ITEM: Development Preliminary Plan (also known as OP Development Stage Plan), Preliminary Plat, and Conditional Use Permit: An application to allow an Open Space Preservation development called Whistling Valley III (West) located north of 10th Street and west of the existing Whistling Valley I development.

City of Lake Elmo Planning Department
Preliminary Plan, Preliminary Plat, & CUP Review

Request: The applicants are seeking approval of a preliminary plat for Whistling Valley Third Addition to create an additional six (6) units in Whistling Valley on an additional 14.45 acres of gross buildable land.

EXISTING DRAINAGE MAP
WHISTLING VALLEY THIRD ADDITION
ANDERSON SWANSON HOMES, INC.
 LAKE ELMO, MINNESOTA

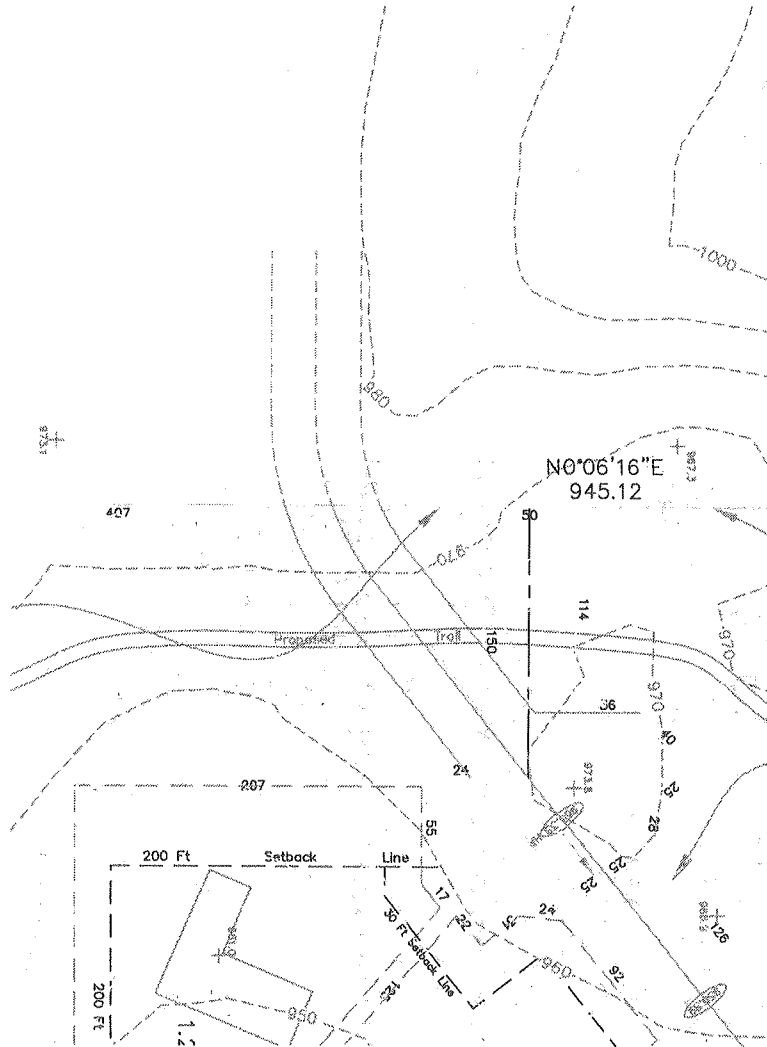
2. The compound outlet routing for Island Depression Pond (2P) is incorrect. Device #3 (stool grate inlet BH2) should be routed into device #1 (24" pipe leaving the structure). Using a 48" diameter horizontal orifice to represent a stool grate catch basin inlet will overestimate the capacity of the structure. Update the model using the grate inlet capacity. What is Device #2? Provide more detail on the Island Depression design and "Epic Storm Water Storage Device."

3. Provide a geotechnical report verifying the soil infiltration characteristics and water table at the Island Depression location.
 4. The Central Drainage Area (3S) is not routed into the proposed pond system, although it appears to drain overland into Cell 1 (3P) on the grading plan. Update the model and grading plans as necessary and resubmit.

6. The East Area (5S) goes through the middle of the surface swale draining into Cell 1 (3P). Update the drainage area.
7. Provide details for the compound pond outlets for Cell 1 (3P) and Cell 2 (4P) showing orifices, weirs, and pipe sizes and inverts.
8. Design Cell 2 to handle up to the 100-year event, maintaining freeboard and without flow over the emergency overflow.
9. Add notes to the grading plan indicating the location and elevation of the emergency pond overflows.

1. Provide a maintenance plan and agreement for Island Depression and both cells of the storm water pond system.
2. Pond 1P (Natural Depression) pools up and flows over the roadway and into Pond 2P (Island Depression) on 10- and 100-year events. Flow over the roadway is not allowed.
3. Pond 2P (Island Depression) pools up and outlets over the roadway and into the surface drainage swale on 10- and 100-year events. Flow over the roadway is not allowed.
4. Verify the volume control. The site drains to landlocked Goose Lake. The watershed district is likely to comment on the volume control.
